GSGNY Bid Addendum Two (2)

Date: 8 July 2022

Project Name: Girl Scouts of Greater New York (GSGNY)

Project Number: 2005

**ALUM. STOREFRONT
SYSTEM & DOOR SCHED.**

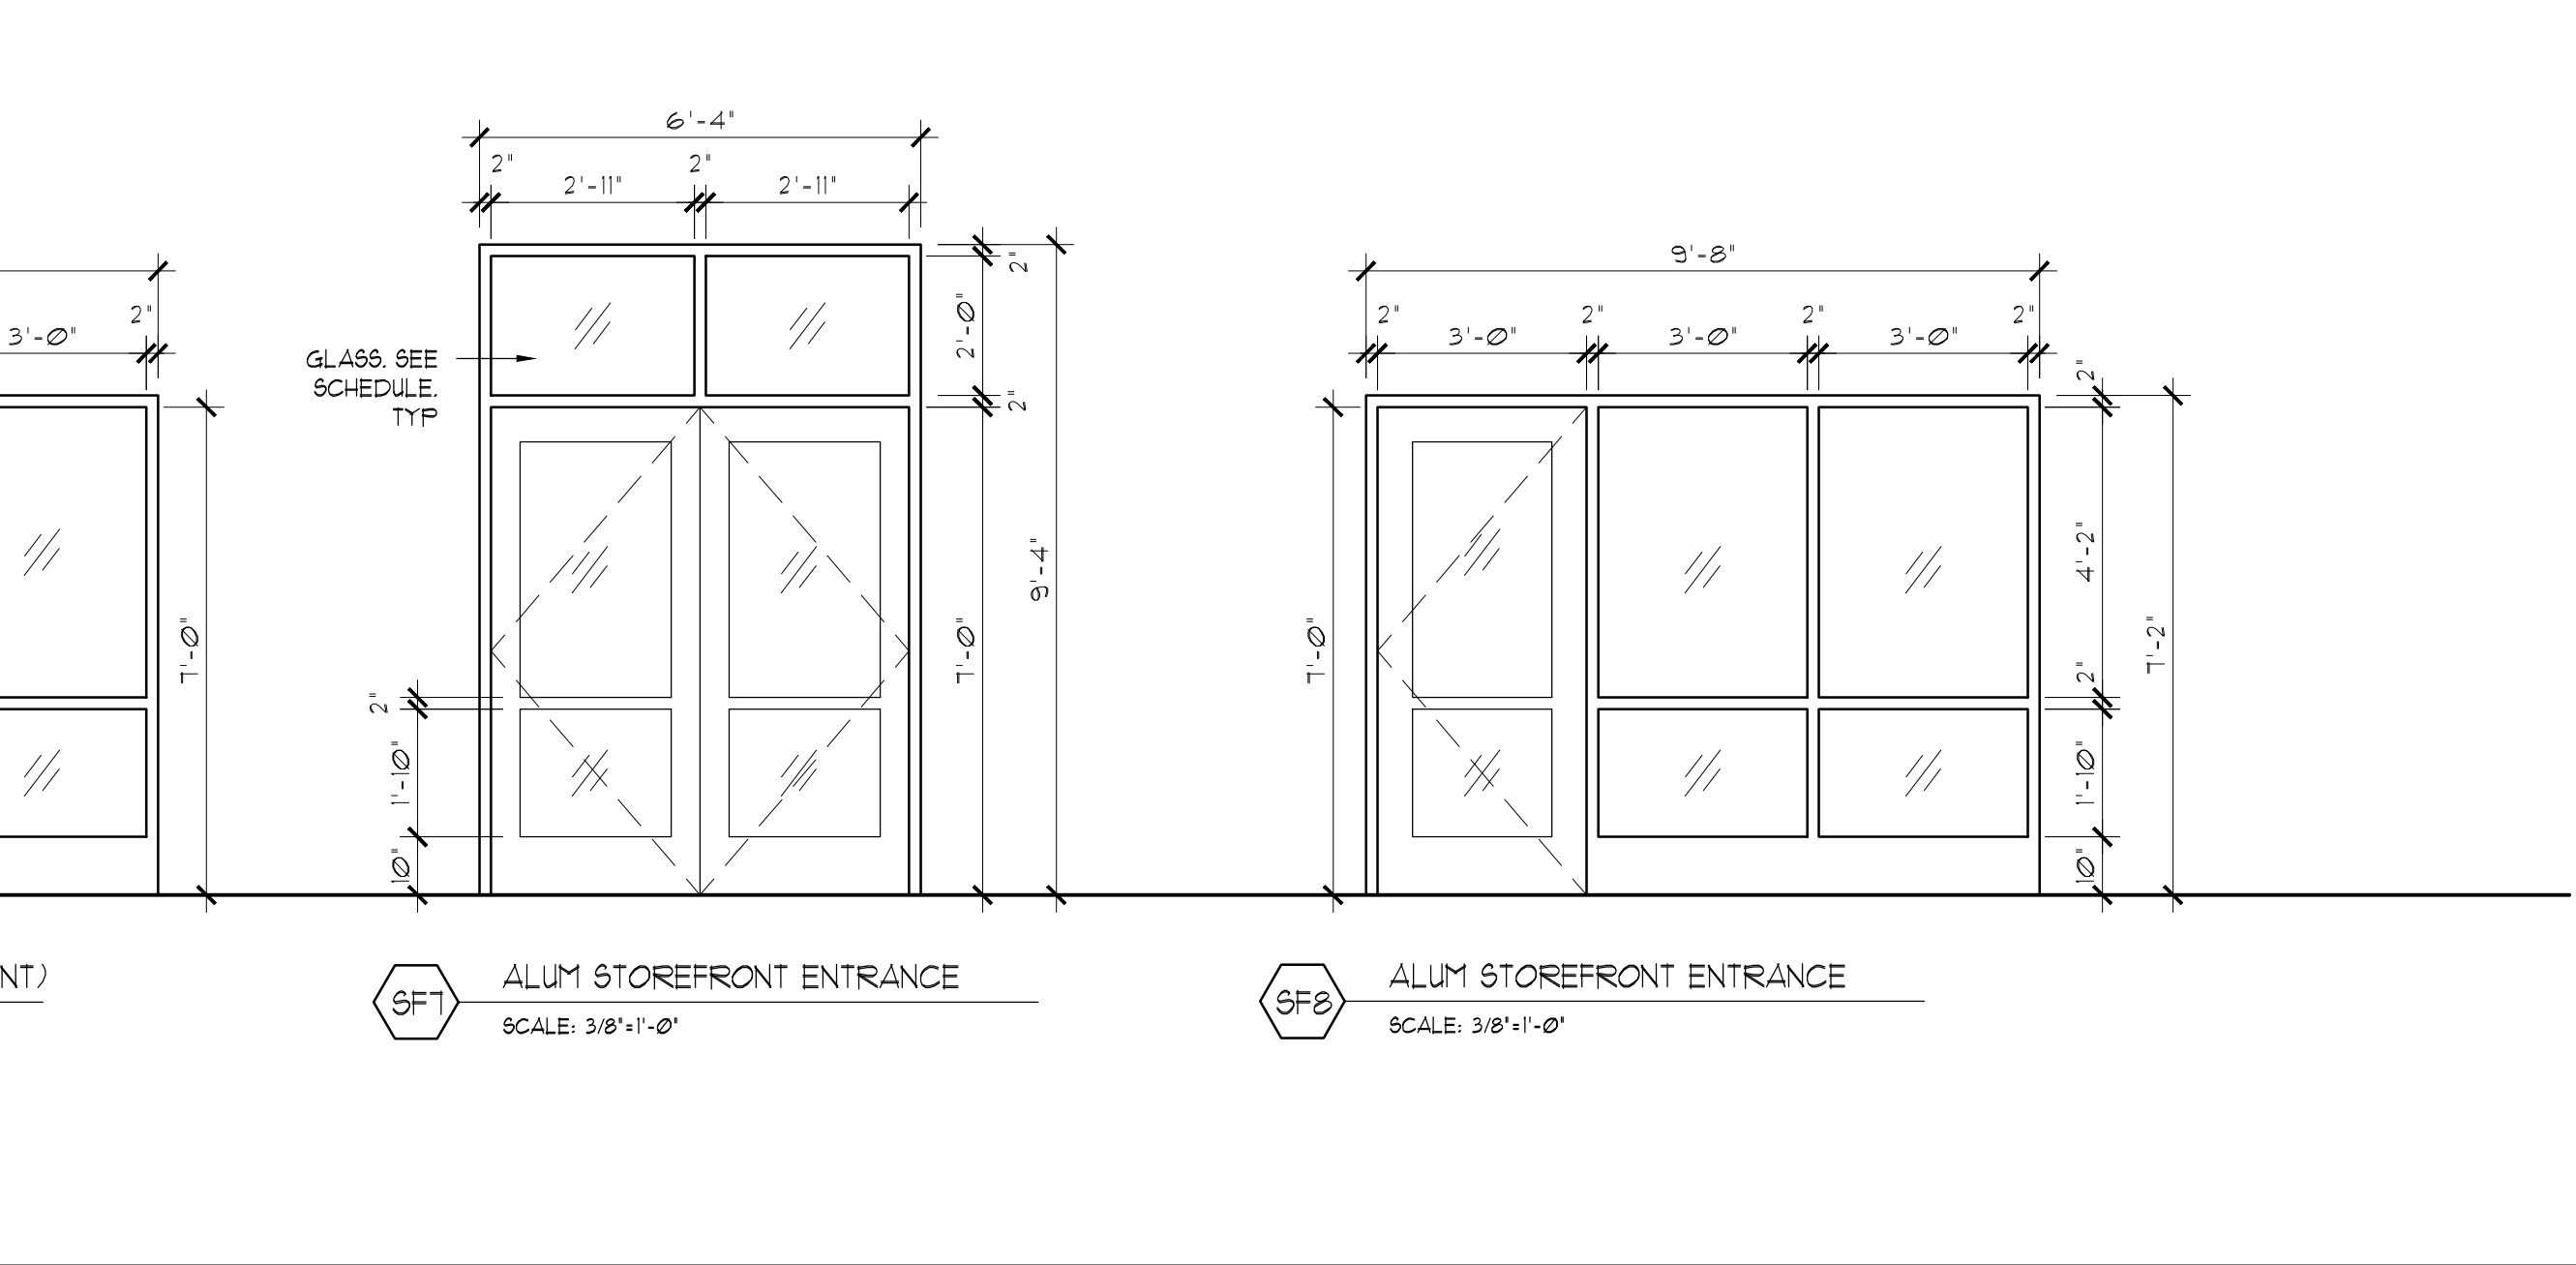
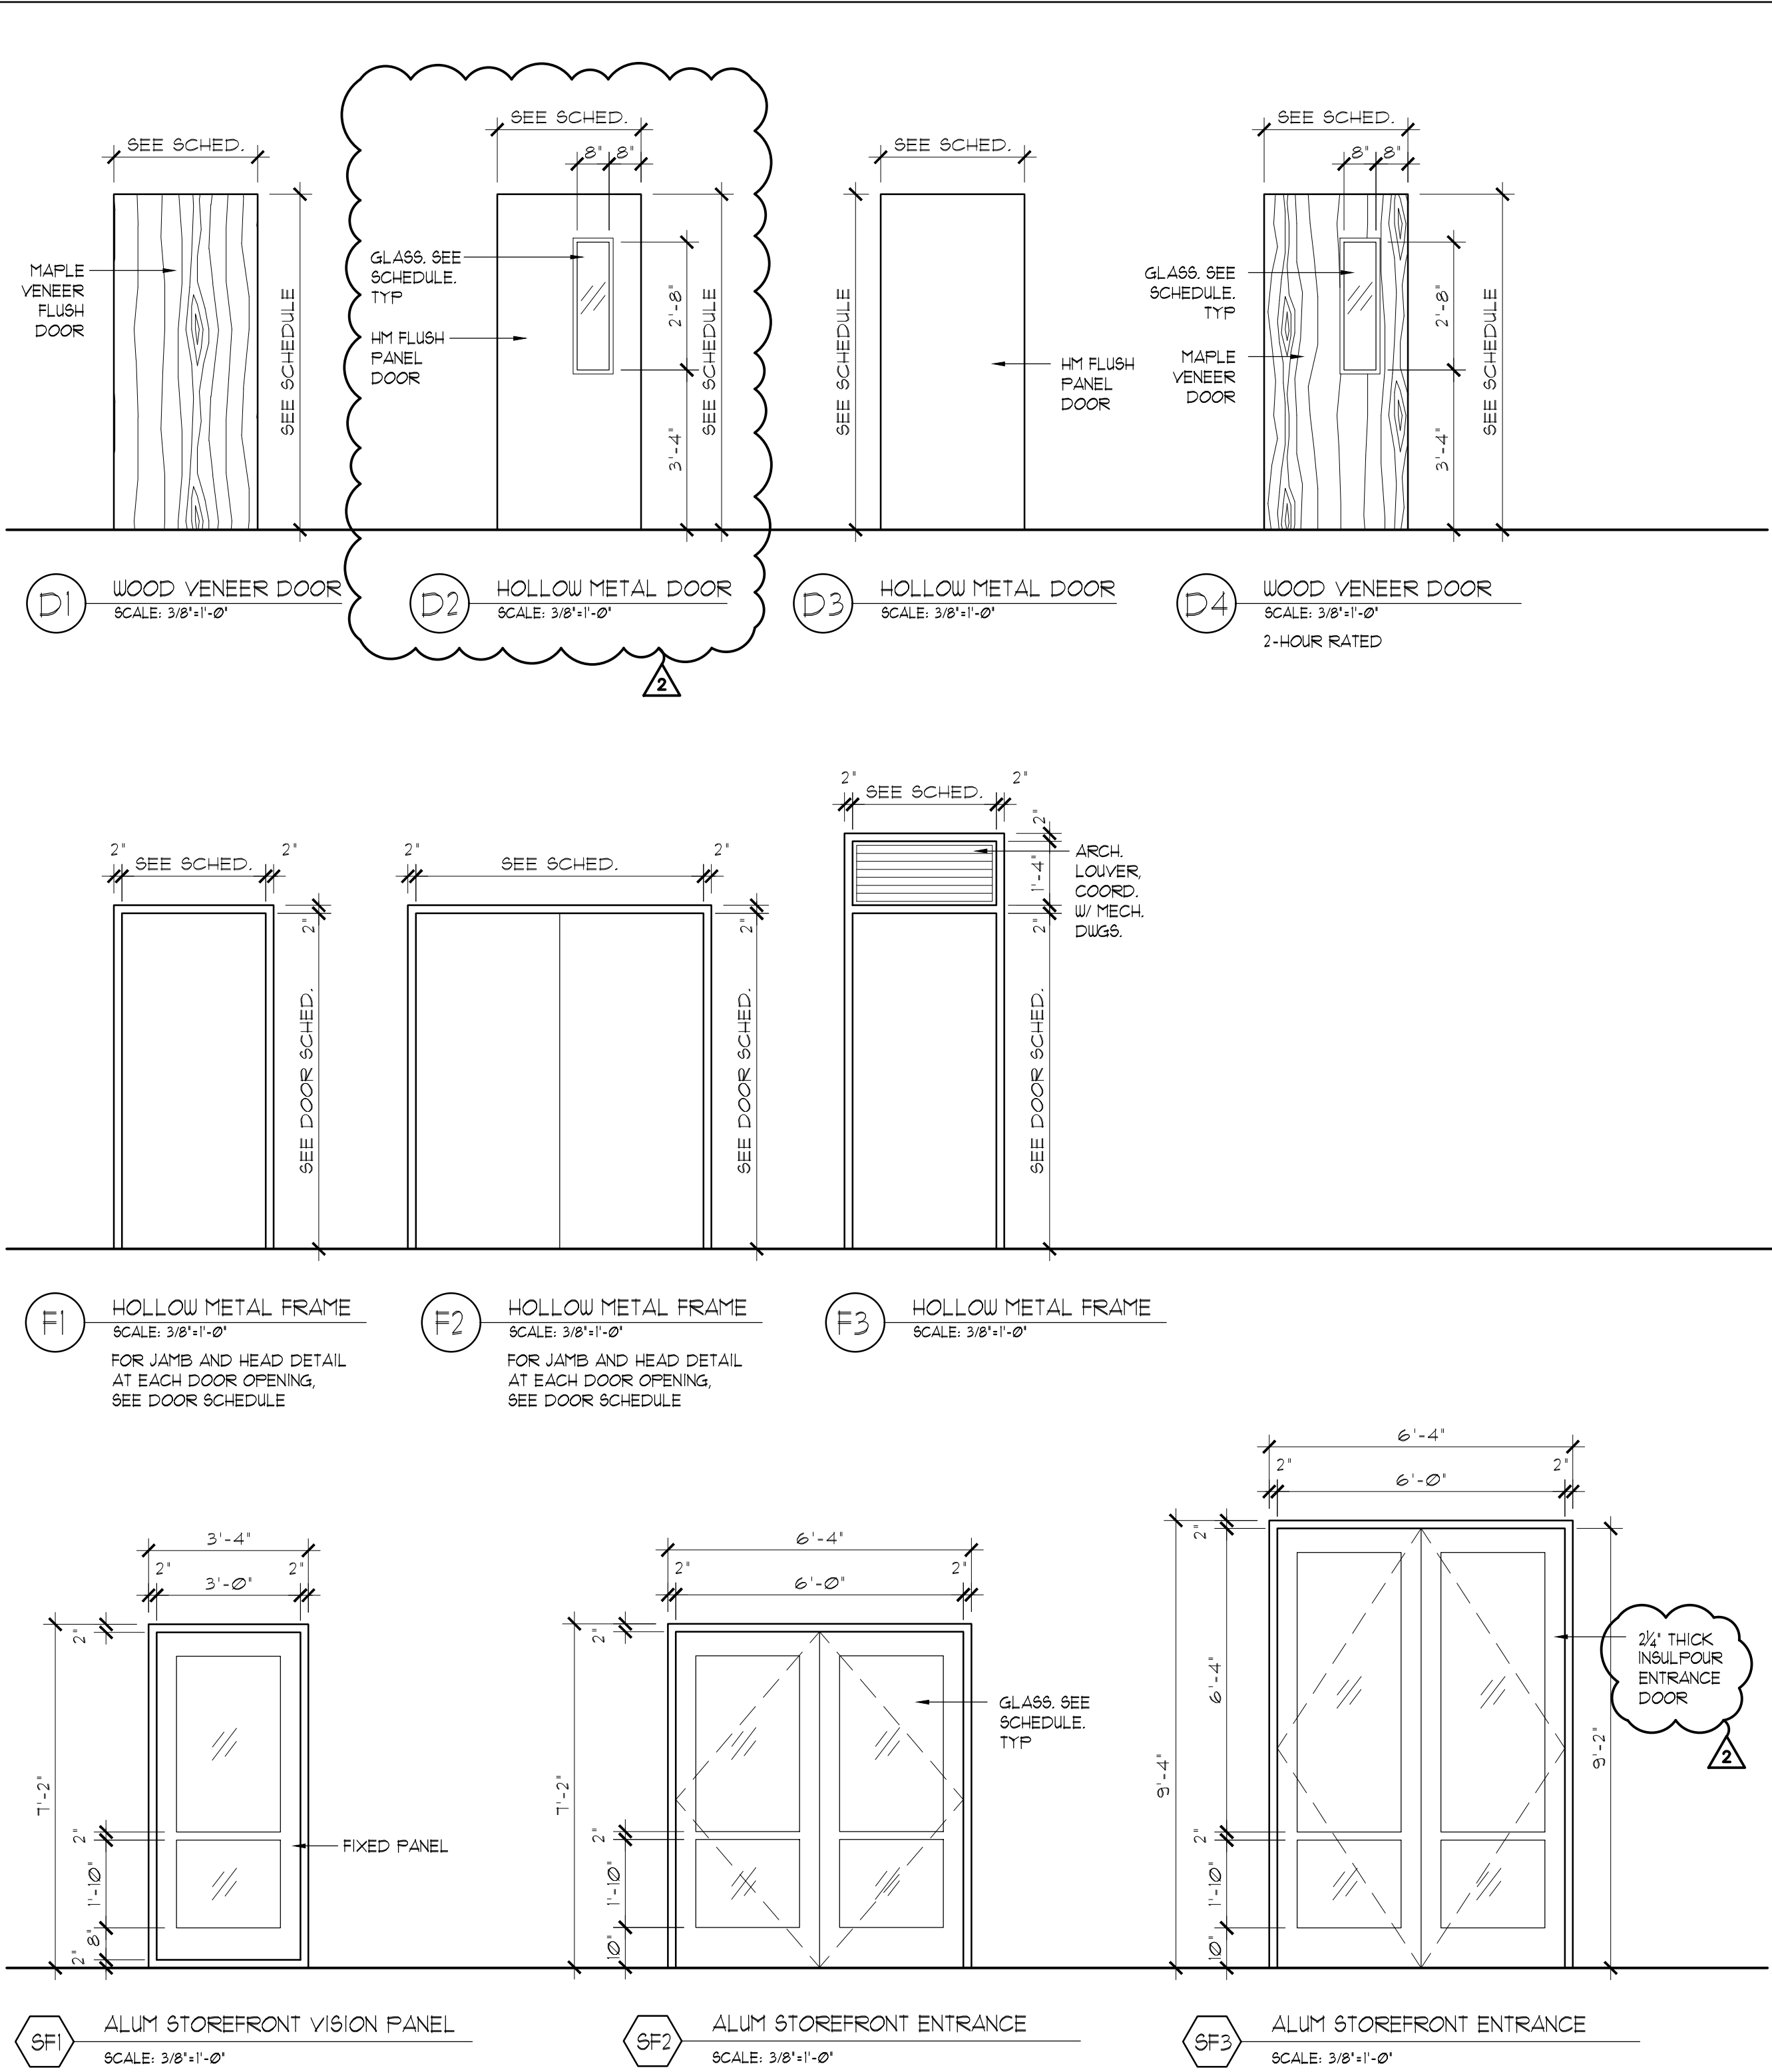
2. **Exterior Glazing:** In order to meet the Performance Criteria required by the Energy Analysis, all glazing in the exterior storefront and exterior aluminum doors, identified as GL-2 on A-900 and A-901, shall be as follows. This Specification supersedes all other descriptions in the Drawings or Specifications. The outdoor lite shall be ¼" clear tempered glass with a Solarban 60 coating on the #2 surface. The ½" airspace shall be filled a 95% argon and 5% air mix. The Indoor lite shall be ¼" clear tempered glass with an Energy Select 73 coating on the #4 surface. The performance ratings are as follows: U = 0.20, SHGC = 0.37 and VTL = 66%.

4. Door #101/ Aluminum Storefront Entrance SF-3: due to the height of the doors, the Specification for this opening only shall be changed from the Kawneer 500 Standard Entrance Door to the Kawneer 2 ¼" Series 500T Insulpour Entrance Door.
